FW: F/25/100141 Land SE of Kings Copse Avenue - landscape comments

Landscape General Arrangement Plan

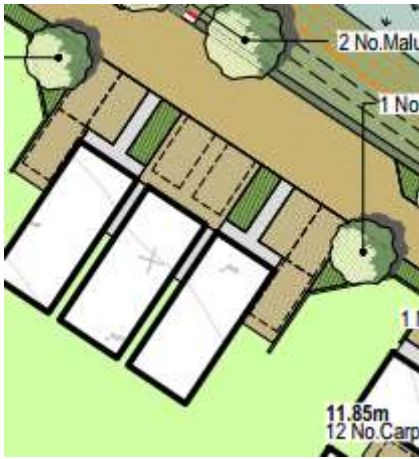
1/ The approach taken to the landscape proposals around the periphery of the site is generally welcomed. The tree planting along the frontage along Kings Copse Road will improve the character of the road and create a pleasant foredrop to the site. The protection and enhancement of the existing green buffers to site edges is an important aspect of the of the scheme. Currently it is not easy to decipher the various types of planting indicated (with differing shades of green). Some explanatory notes of planting types on the plan would be helpful in this regard. There are locations where wildflower meadow mix (shade tolerant) needs to be replaced by native tree and shrub planting to ensure boundaries are bolstered and screening improved. There is also scope to increase the number of individual new trees planted within the buffer zones.

2/ Having read through the DAS, the suggested proposed green zones shown on the concept plan are not immediately evident on this latest plan. The central square can be identified (although it is debatable whether this can be described as a green zone since there are extensive sweeps of hard surfacing in the area). The 2 secondary green zones have largely been lost with only pockets of soft landscape remaining.

The design of the central square is one of the most disappointing aspects of this latest proposal and requires further refinement to try and avoid this key space being dominated by vehicles and hard surfacing. At the very least the square should be developed as a shared space incorporating some home-zone type principles. At present the plan is rendered in a way that does not even suggest a change of material/colour of the surfacing. Further thought should be given to improve this key focal space and we would appreciate a detailed extract providing more detail of the design in this area.

3/ In terms of deliverable Green Infrastructure, especially street tree planting, I do not agree with the suggestion that the scheme has been landscape led (*'has a landscaped form at it's inception'*). Perhaps around the periphery it is possible to see how landscape has been prioritised in the design, but internally tree planting generally seems to be arranged where remnant soft landscape areas have been left after setting out buildings, roads and parking. There are few locations where contiguous avenues of tree planting occur and trees are often set far apart which will preclude canopy level green linkages.

Please review the plan and maximise numbers of trees to be planted. For example:

Where a tree might have to be positioned in narrow strips introduce specialist tree pits so the tree can be successfully planted.

4/ Too many parking courts are devoid of tree planting and as a result these spaces will be bland and exposed. Each area should be closely reviewed and every opportunity to increase tree planting to provide shade and shelter should be maximised.

5/ There are a notable number of trees planted in narrow beds between parking bays, and these should be provided with specialised tree cell pits if they are going to survive. Please these trees on the plan for clarity.

6/ SuD's - there are 4 basins indicated on plan. Currently these are notionally indicated as having a rather engineered, geometric form. Further design work is required to ensure these have a more naturalistic form with sweeping curves, shallow banks with varying slopes angles. There may be scope to introduce low gabion walls as informal berms to create a basin with 2 different levels. Please avoid off-the-shelf concrete headwalls using instead gabions of sandbags. Limit any required safety railing to absolute minimum as this can be visually intrusive.

Some further native shrub planting should be added around the top of the ponds to soften the form of the basins. This planting should be arranged in an informal and naturalistic manner.

7/ Where shrub and groundcover planting abuts the sides or ends of parking bays, allow for a min. 0.3m wide strip of shingle or bark mulch to allow for access or overrun without damaging planting.
